SUBMISSION TO THE PRIORITY PROJECTS STANDING ADVISORY COMMITTEE
WHITEHORSE PLANNING SCHEME AMENDMENT C245.

We thank the panel for the opportunity to make a submission on the proposed draft planning amendment C245whse. The amendment seeks to insert a new Incorporated Document into the Whitehorse Planning Scheme titled Box Hill Central North Master Plan (BHCN). The amendment allows the 1.85Ha Site to be used and developed in accordance with the BHCN with 7 towers, consisting of 1777 apartments, 83,203 sq m commercial office space and 4,280 sq m retail space.

Re: Planning Applications - WH/2021/466, 476, 597 – Vicinity developments Main Street Box Hill.

Re: Planning Applications - WH/2021/466, 476, 597 and WH2021/304 – Vicinity developments Main Street Box Hill.

MASTERPLAN PROPOSAL 3.13 MOVEMENT AND ACCESS

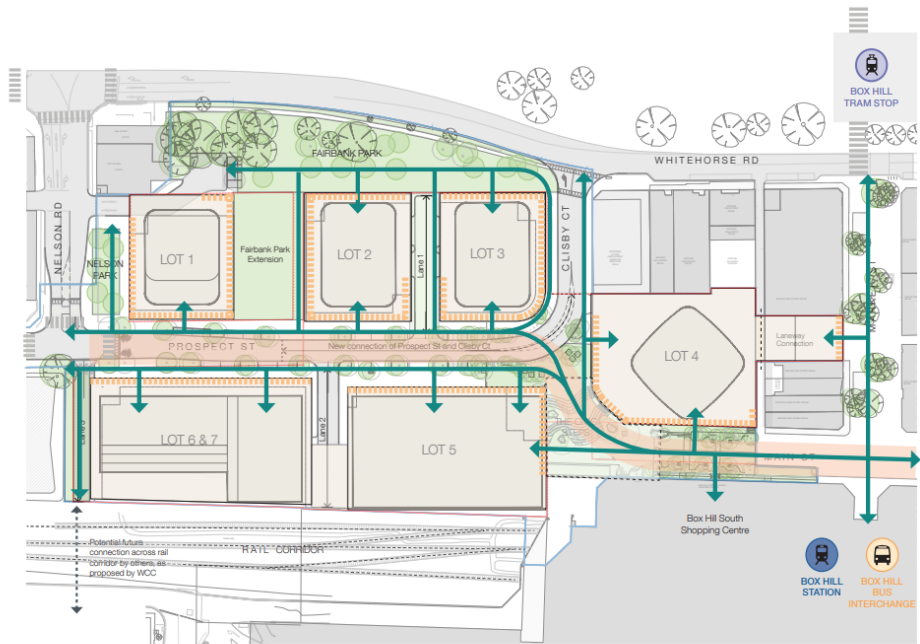
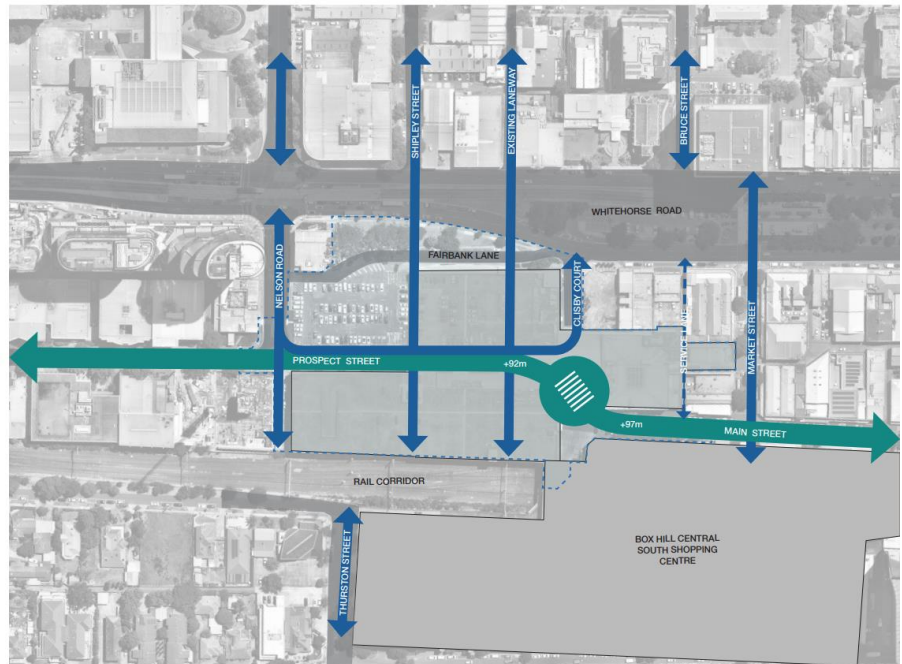
1. Why, in The Master Plan Report there is no Movement and Access diagram for cycling.

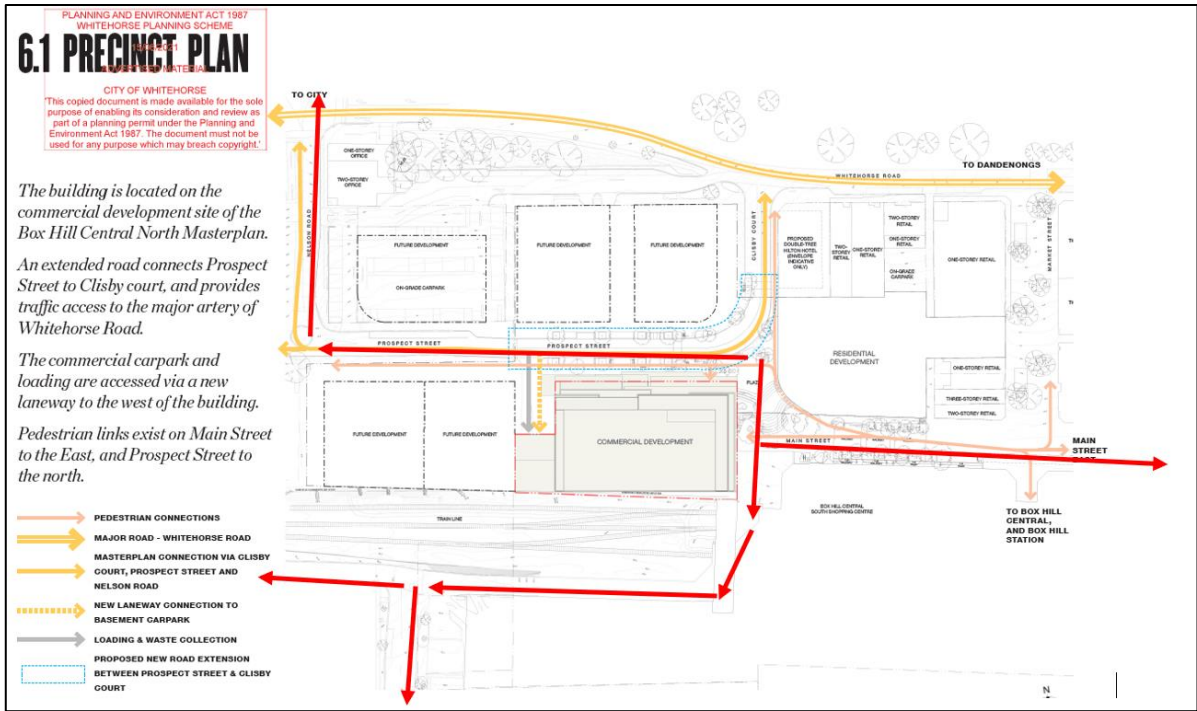
The Site Response has omitted the existing N/S Active Transport connections (red arrows) that the loading bay bridge currently supports. Local residential connections to sporting and open space precincts lost:

- North - Box Hill Gardens and Hagenauer Reserve from residents living south of the railway line.
- South - Surrey Park, which includes Aqualink swimming and sporting complex, sporting ovals and Surrey Dive passive recreation areas to residents living north of the railway line.

The Precinct Plan has not included the existing Strategic Cycling Corridors Network into its plans (Red arrows).

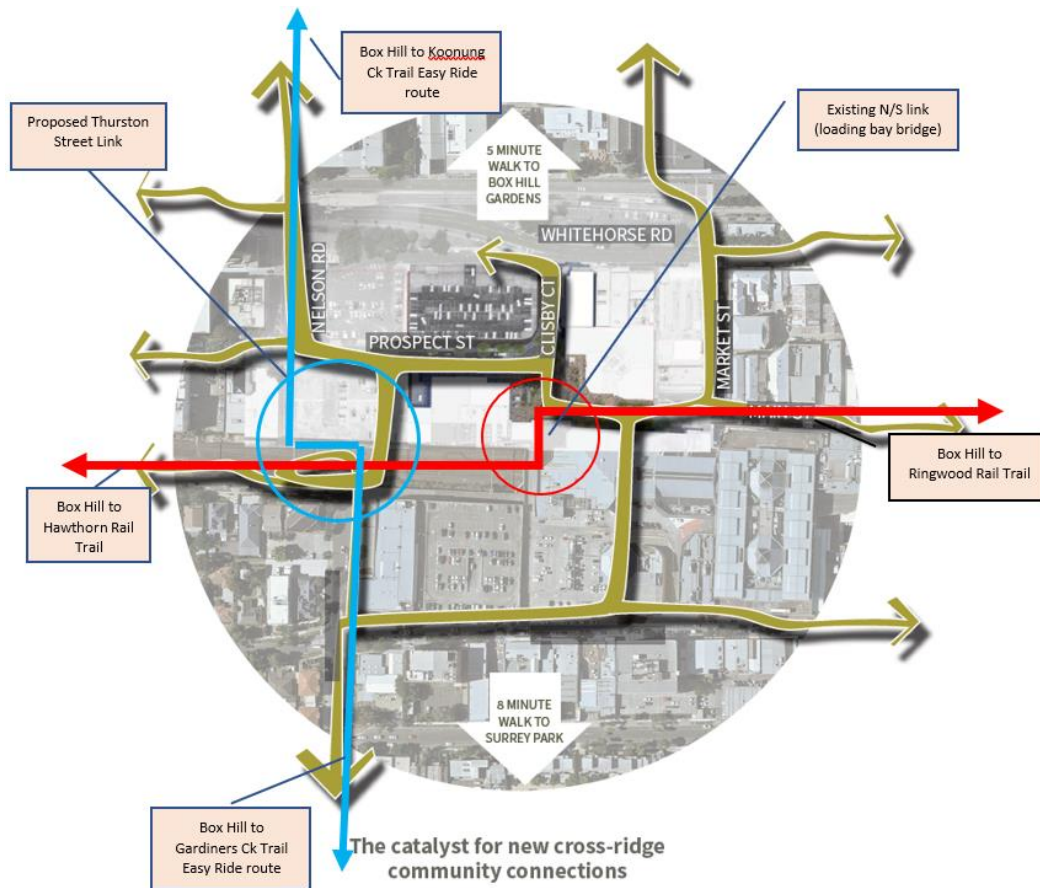
Strategic Cycling Corridors (Red and Blue) in concept, strategy and master plan documents, omitted.

Figure 4.2: Woolworths Loading Access

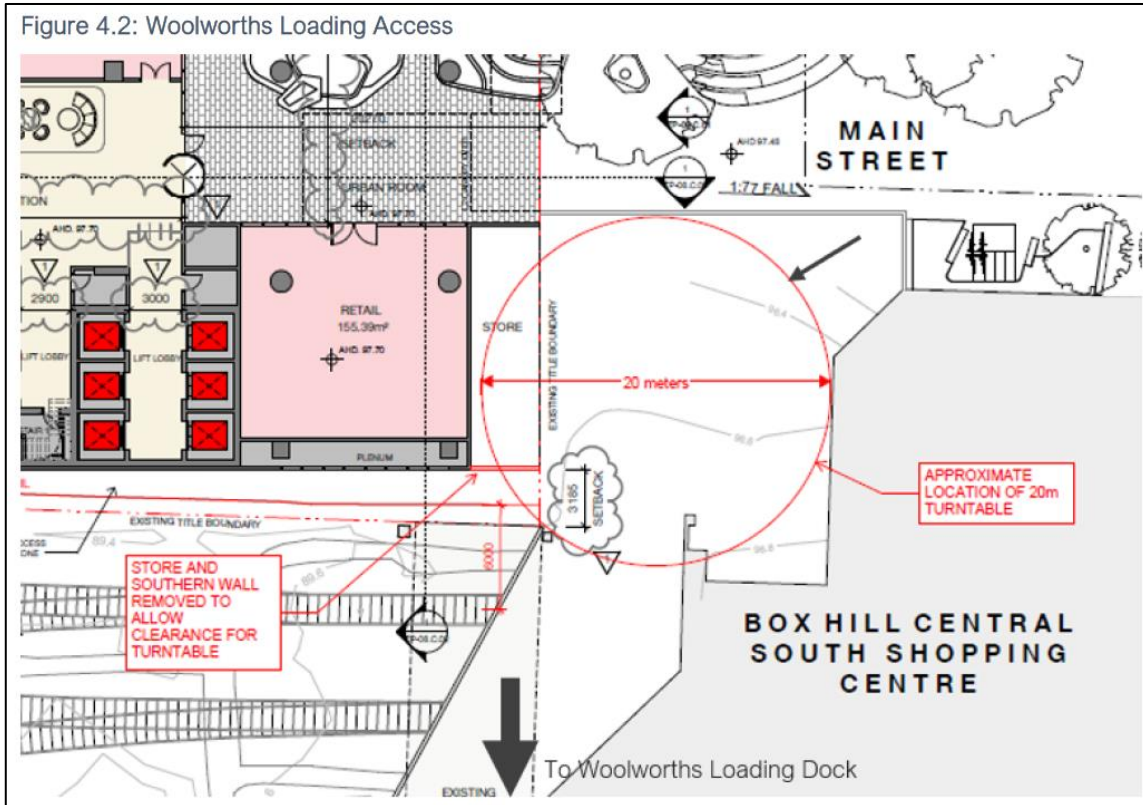
Loading Bay turntable resulting in closure of loading bay bridge to cyclists and pedestrians.

The modified loading area will be physically separated from the new Main Street pedestrian connection by a screen which will be integrated into the canopy structure. With the existing loading bay connection lost and no commitment to a Thurston Street crossing, there will be no north/south or east/west Strategic Cycle Corridors at Box Hill.

We suggest some options to maintain the Active Transport linkages across the loading bay bridge at least until a better alternative is provided at Thurston Street, these could be incorporated into the existing works.

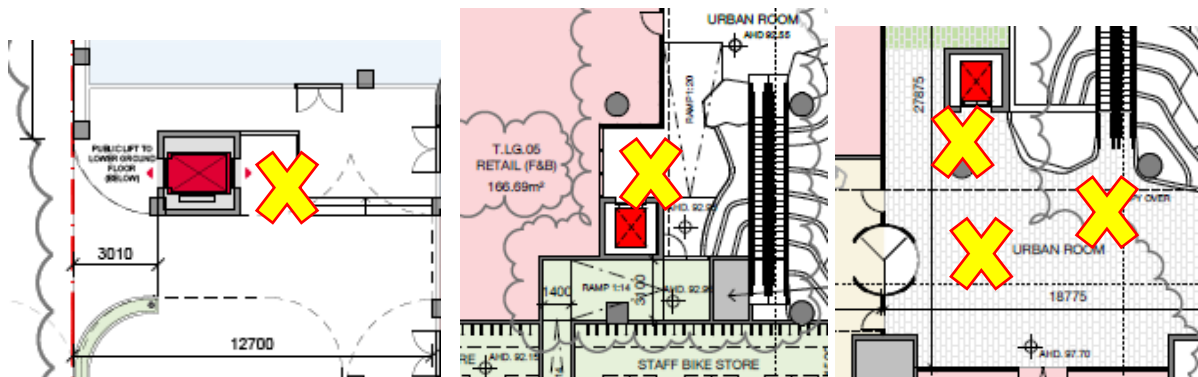
The proposed lifts are inadequate in size for the anticipated number and type of users. The urban zone waiting space is constrained for the expected bicycle usage. The lifts must be equivalent in size to those in large shopping centres, at COSCO or Melbourne Airport carparks, which accommodate a number of people with large shopping trolleys or travel luggage. Waiting space in the urban zone must be generous. The stairs must be configured to enable a bicycle to be wheeled along a ramped edge.

The images below, from the plans (residential P7, Commercial P6&8) show inadequate lift size and conflict areas in the Urban Zones of the external public lifts:

1. Residential tower lift with less than 3m space in the waiting area for people and bicycles to access the lift doors via a 90 degree turn.
2. Commercial - The Prospect Street entrance – small waiting area space and conflict between lift users making two 90 degree turns to and from the lift doors mixing with people accessing cycle parking facility.
3. Commercial - Main Street entrance conflict paths for users moving to and from lift, escalator and office door entry.
